ADA Curb Ramp New Construction Inspection Form (Blended Transition)

NW MAIN ST

24953

NW NORTH AVE

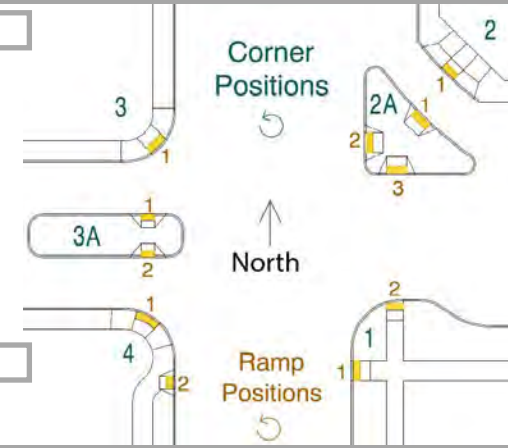
Gutter Flow Slope

2.3

☒

GFS fail workmanship
